8. McCollum Tract 2022 Addition; KPB File 2022-108 Segesser Surveys / Northwest Development Inc. Location: Kenai Spur Highway Salamatof Area

ITEM 8 - McCollum Tract 2022 Addition

KPB File No.	2022-108	
Plat Committee Meeting:	August 8, 2022	
Applicant / Owner:	Northwest Development Inc of Kenai, AK	
Surveyor:	John Segesser/ Segesser Surveys Inc	
General Location:	Salamatof

STAFF REPORT

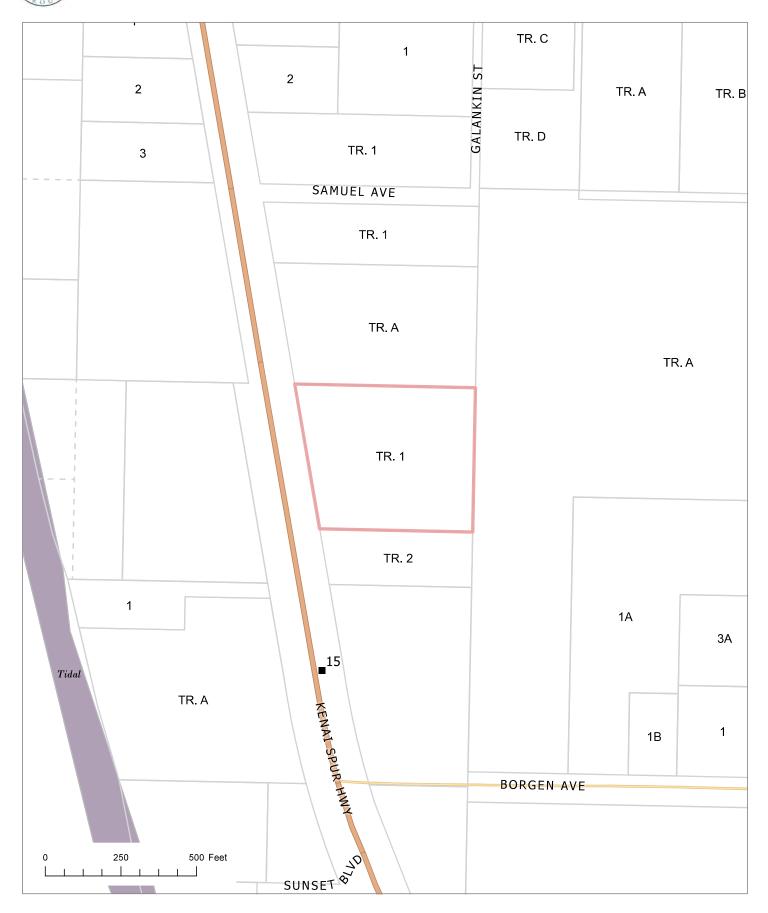
Revise the width to 30' for the existing easement in Note #6 per HEA comment.

Staff recommendation: Fix typo in owner's name

Staff recommendation: Centerline of Kenai Spur Highway should be shown if whole ROW won't fit.

Staff recommendation: Looks as if the parking lot may encroach out into the road dedication

Staff recommendation: It appears there is one access being utilized for both tracts. A joint ingress – egress easement for access should be drawn up and filed and shown on the Final plat.

Staff recommendation: Show centerline of road

Staff recommendation: Add record datum information to the drawing as indicated in legend.

Staff recommendation: Add bearings and distances to the lines below the tracts in the subdivision below on the drawing.

Staff recommendation: There is an icon in the northwest corner of Tract 1B that is not in the legend, either remove from drawing or add to legend.
